1 DEPARTMENT: ENGDRN - STORMWATER REVIEW REVIEW ITEM: 6.13.10.B - Copy of NPDES Permit or NOI

## DEVELOPMENT REVIEW PLAN APPLICATION

A. PROJECT INFORMATION:				
Project Name: Champion Vision Ocala				
Parcel Number(s): 21521-001-02				_
Section 03 Township 15S Range 21E	Land Use Com Zo	ning Classifica	ation B-2	
Commercial Residential Industrial	Institutional   Mixed Use	Other		
Type of Plan: MAJOR SITE PLAN				
Type of Plan: MAJOR SITE PLAN Property Acreage 1.09 Numb	er of Lots NAA	Miles of Ro	oads N/A	
Location of Property with Crossroads 1900 ft w	vest of NW 44th Ave on south side of I	JS 27		
Additional information regarding this submi-	tta1: Construct one (1) medical vision	office in an existing	commercial subdivision with	
a master stormwater system

## A MARION COUNTY MAJOR SITE PLAN FOR

C001

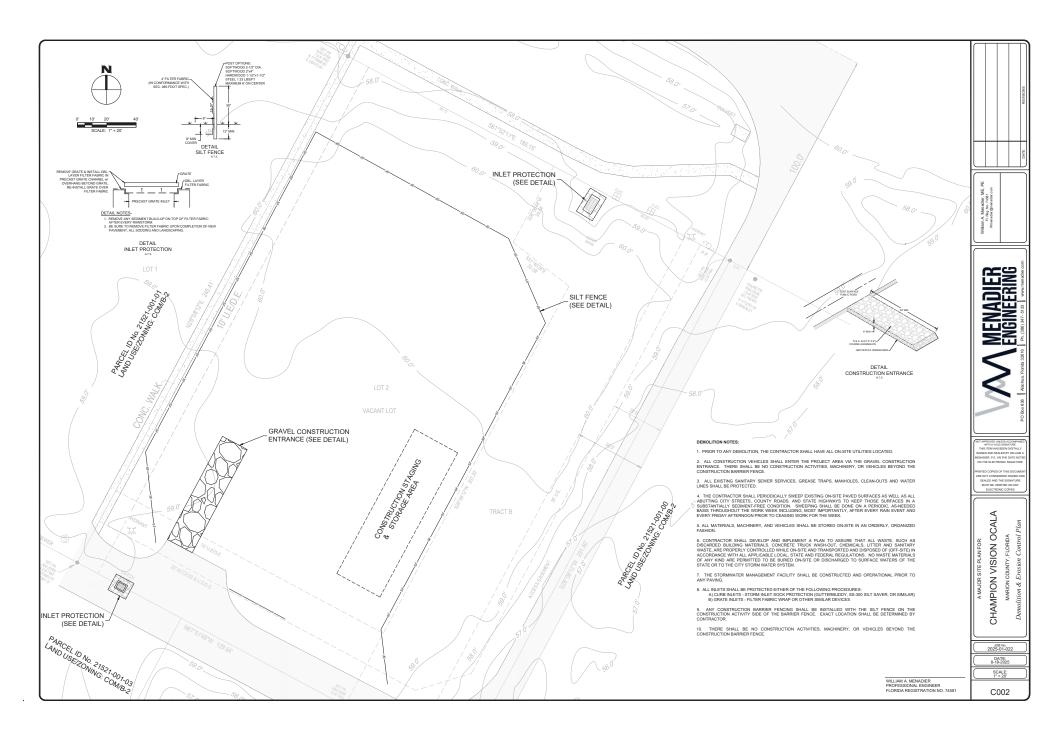
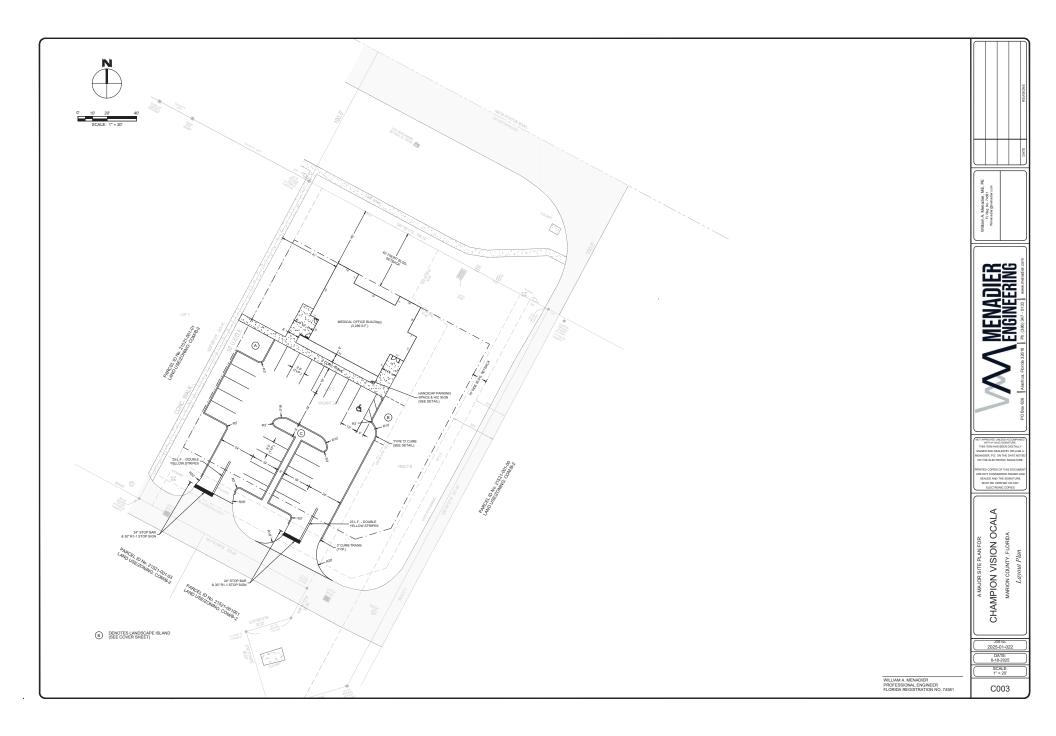
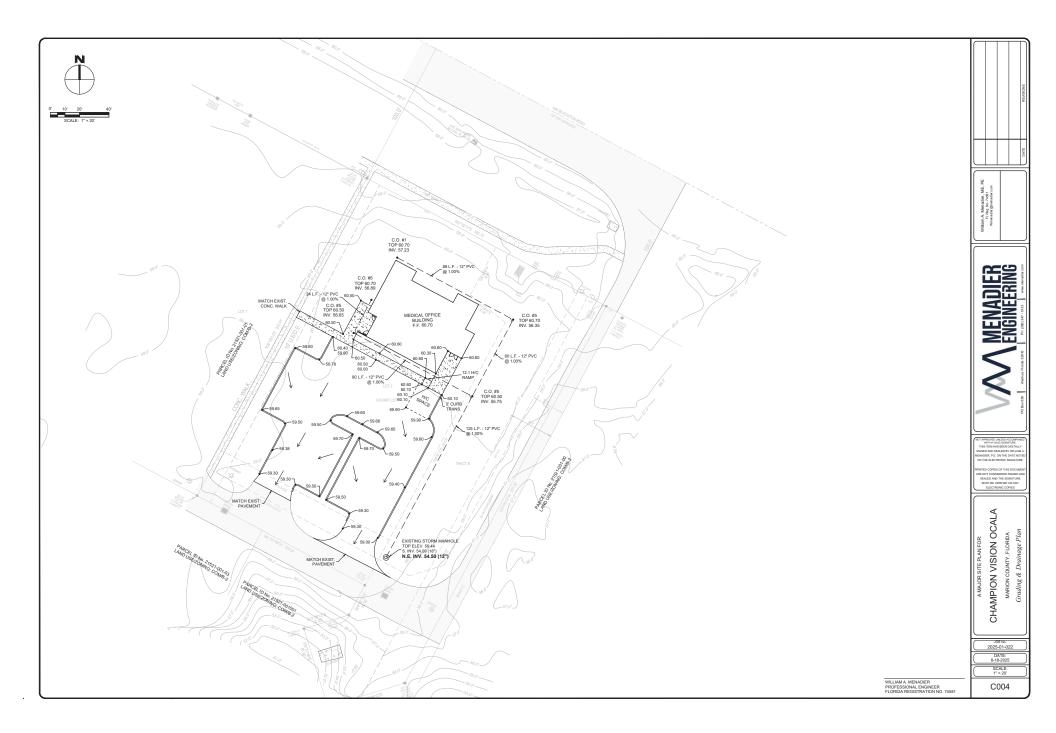
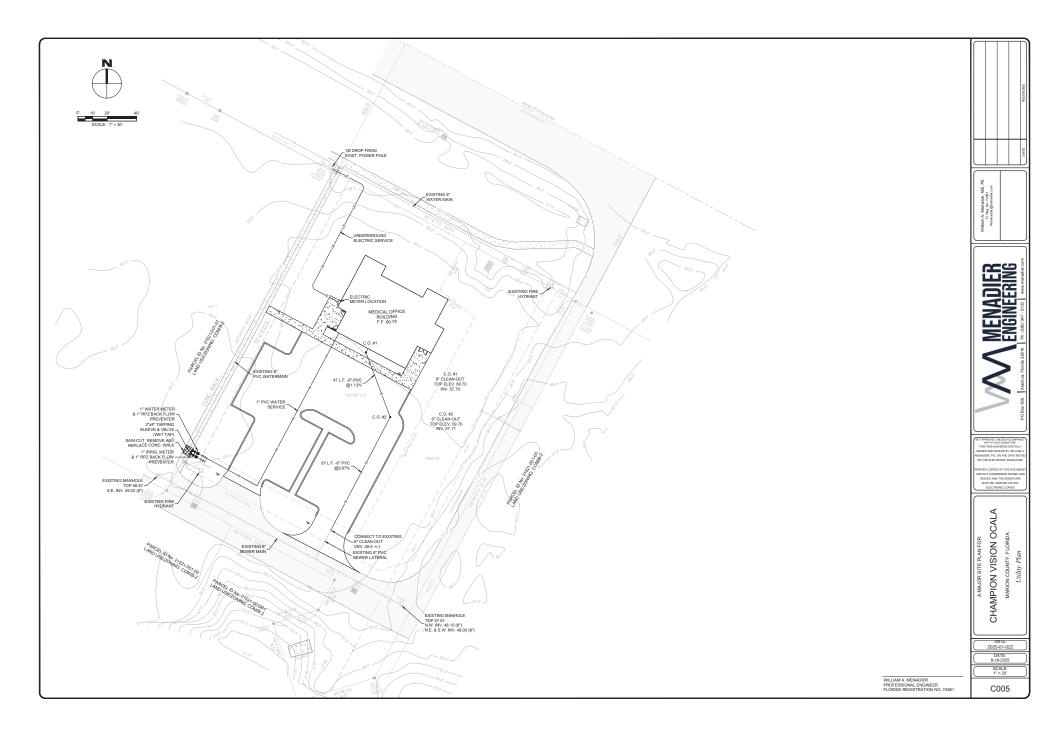
REMARKS: PID#21521-001002 does not exist any longer. Please remove from cover sheet. Leave the

21521-001-02 parcel on cover sheet.

FLORIDA PLAN LANDSCAPE CHAMPION COUNTY MARION

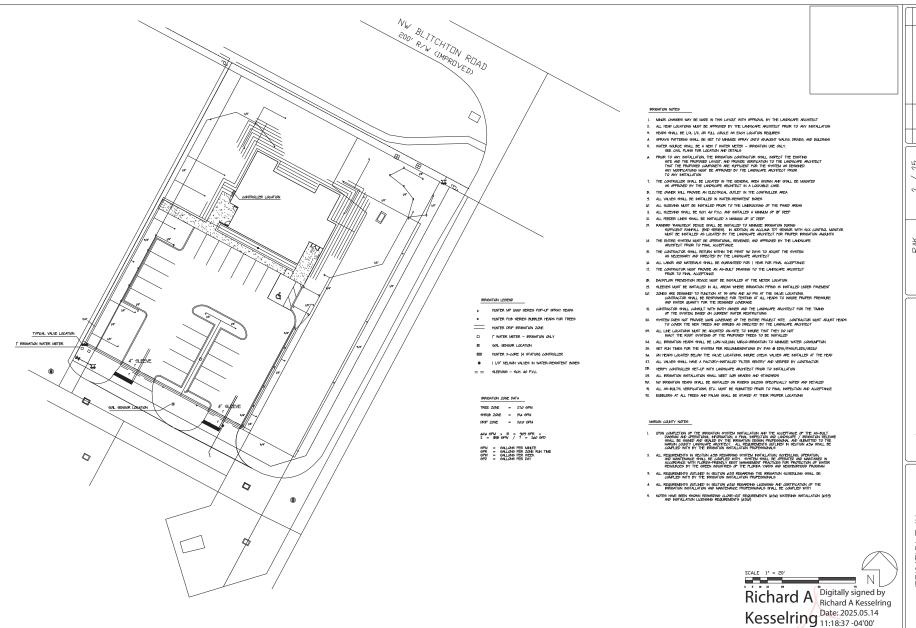
REMARKS: 1.Sweet Viburnum next to building may get to large, consider alternative. 2. Top of tree

rootball should be 1-2" above finish grade

REMARKS: Walter's Viburnum should be the full size variety, not the dwarf variety
